# Access Compliance Report

## Public Rights-of-Way

### (Curb Ramps)

Intersection ID: 25823	Main Street: BANNINGTON_RD	Cross Street: PINEVILLE-MATTHEWS_RD	Location: SW
ADA ID: 69AE74F3919E	Ramp Type: PerpDiag	Initial Pass/Fail: Fail	Overall Compliance: No
		Severity Score: 30

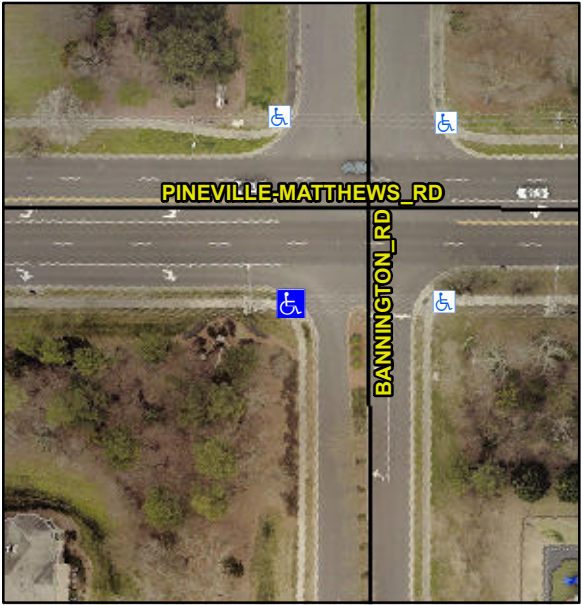
Codes/Mitigation Info/Possible Solution			Field Measurements/Component Compliance		
	Possible Solutions:		<b>Compliance</b>	<b>Description</b>	<b>Data</b>
	<b>Remove &amp; Replace Curb Ramp With Two New Directional Ramps or Equivalent.</b>		<b>Yes</b>	Ramp Length (in)	96.0
			<b>No</b>	Ramp Width (in)	32.0
			<b>N/A</b>	Flare Type LT	N/A
			<b>N/A</b>	Flare Slope LT (%)	N/A
			<b>N/A</b>	Flare Traversable LT?	N/A
			<b>N/A</b>	Landing Length (in)	N/A
			<b>N/A</b>	Landing Width (in)	N/A
			<b>N/A</b>	Landing Slope (%)	N/A
			<b>N/A</b>	Landing X Slope (%)	N/A
<p>Surveyor Notes:</p> <p><b>N/A</b></p>			<b>N/A</b>	Landing Curb? (Y/N)	N/A
			<b>N/A</b>	Shared Landing?	N/A
			<b>N/A</b>	Gutter Ponding?	N/A
			<b>N/A</b>	Gutter Lip Ht (in)	N/A
			<b>No</b>	Painted X Walk1?	N/A
			<b>To E</b>	X Walk 1 Direction	To N
			<b>N/A</b>	X Walk 1 Width (in)	N/A
			<b>1.6</b>	X Walk 1 Slope (%)	7.1
			<b>6.3</b>	X Walk 1 X Slope (%)	1.3

<b>N/A</b>	Ramp inside XWalk1?	N/A
<p>PROW/ADA:</p> <p><b>R304.5.1, R304.5.3</b></p>			<b>N/A</b>	Road Slope (%)	N/A
			<b>2.6</b>	Road X Slope (%)	N/A
			<b>N/A</b>	Any Obstructions?	N/A
				Obstruction Type	
			<b>N/A</b>		N/A
			<b>Yes</b>	Surface Condition? (G/P)	Good
Total Cost:		\$ 3200.00
